**Before the
Federal Communications Commission
Washington, D.C. 20554**

In the Matter of)	
)	
Request For Declaratory Ruling By)	WT Docket No. 07-121
Wireless Strategies, Inc. Regarding)	DA 07-2684
Coordination Of Microwave Links)	
Under Part 101 Of The Commission's)	
Rules

Comments of Comsearch

Figure 1: EIRP Distribution for Digital Transmitters in the 5925-6425 MHz band (Comsearch data 6/30/07)

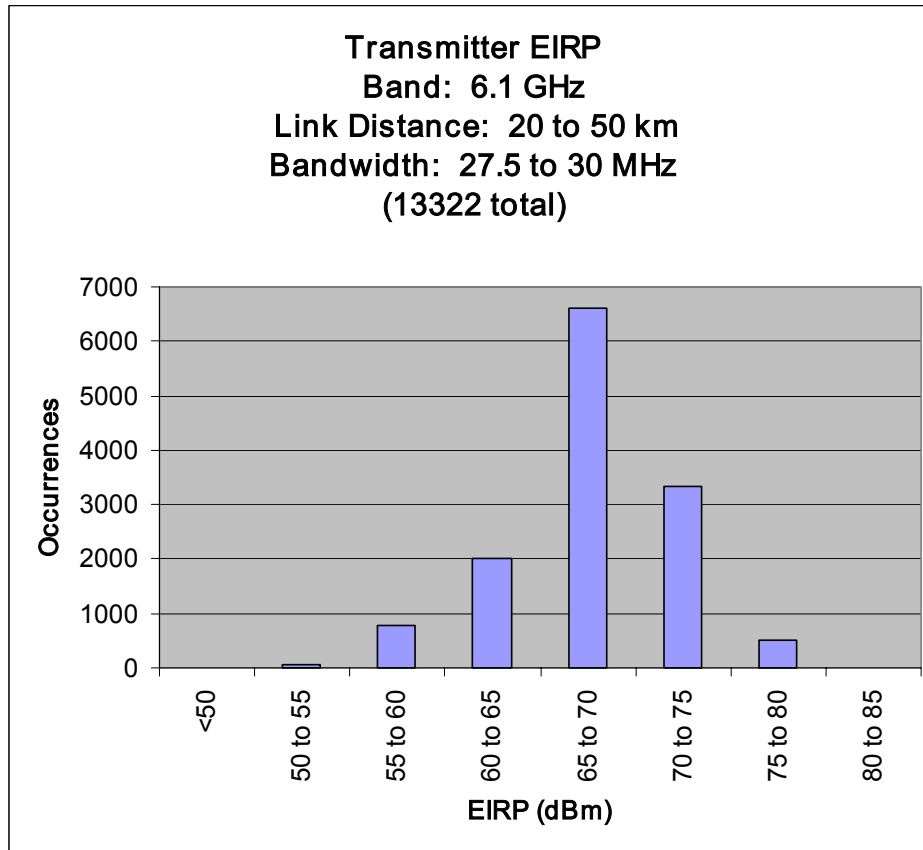
A licensee is not entitled to use the maximum EIRP (usually 85 dBm) on every link; instead licensees are expected to use “the minimum amount of power necessary to carry out the communications desired.”⁸ The median EIRP used by 27.5 to 30 MHz bandwidth digital microwave transmitters in the 5925-6425 MHz band on links in the 20 to 50 km range (comparable to WSI’s links) is 68.1 dBm. Figure 1 shows the distribution. But WSI has licensed every one of its transmitters at the 85 dBm maximum limit.

Further WSI's licensed EIRP is at least 16 dB higher than the median for the band. So combining the high EIRP with the minimal antenna performance, WSI is causing in excess of 30 dB more interference in these directions than necessary if all it wanted to do was communicate between Point A and Point B. As a specific example, our calculations show that with space diversity, WSI's BA Tower (WQHD218) – Mt Laurel (WQHD217) link could meet 99.9999% reliability with EIRP less than 60 dBm.
